Subject: Comments on updated Case Closure Form - Superior Linens

The Department of Natural Resources (DNR) reviewed the modified Case Closure form submitted for the Superior Linens site (BRRTS # 02-41-532649). The following modifications/corrections are still needed to complete the packet:

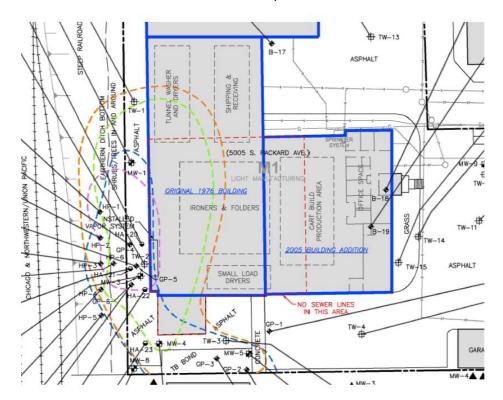
Table A.1 – This table must note that SB-11 and SB-12 are located in the same locations as MW-11 and 12 since they are not labeled on the figures.
